Technical Service Information

FORD AOD-E/4R70W SLIPPING OR PROLONGED 1-2 UPSHIFT

Figure 1

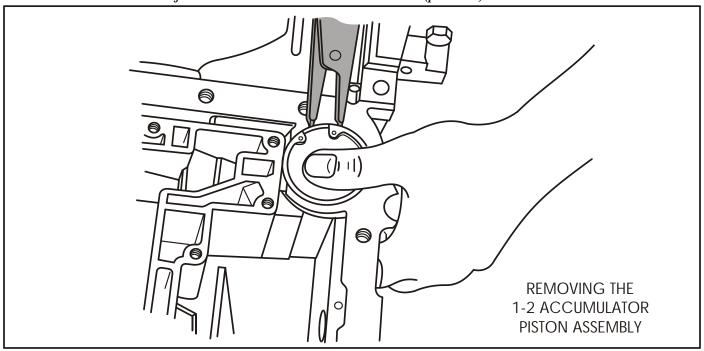
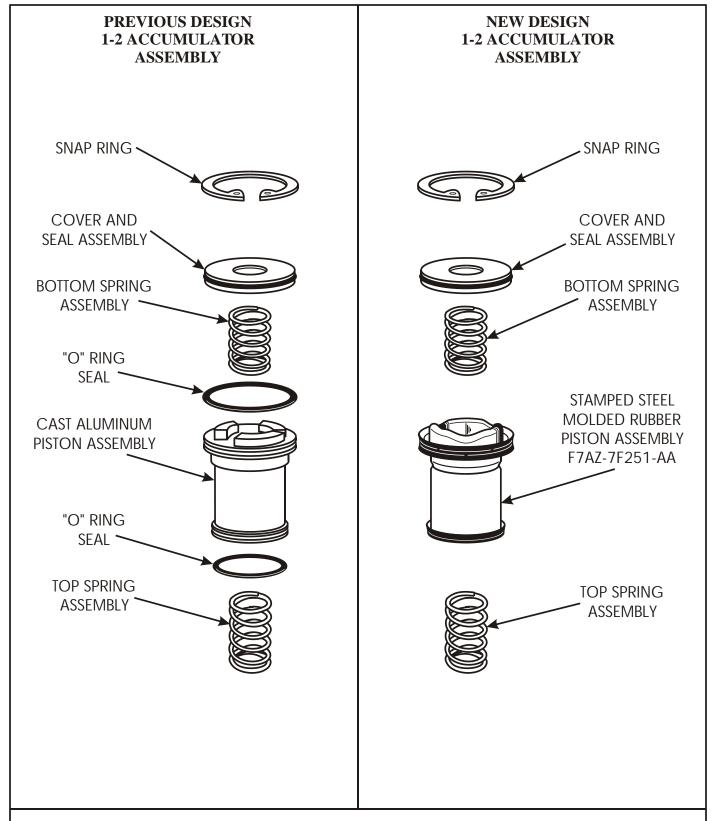
COMPLAINT: Before and/or after rebuild, the vehicle exhibits a slipping condition on the 1-2 upshift, and

sometimes will not be displayed untill some miles have been put on the vehicle.

CAUSE: The cause may be, premature 1-2 accumulator seal wear, which also creates the case

accumulator bore to become scuffed, which leads to the loss in the 1-2 shift.

CORRECTION: Replace the cast aluminum 1-2 accumulator piston with a new design one piece stamped

steel piston with molded rubber lip seals, and replace the top accumulator spring with the revised parts available from Ford Motor Co. Case replacement should not be necessary with the use of the revised stamped steel accumulator piston. Refer to Figure 1 to remove the piston assembly. Refer to Figure 2 for illustration of both design stack-ups, and to Figure 3

for a chart to install the proper revised springs into the proper model.
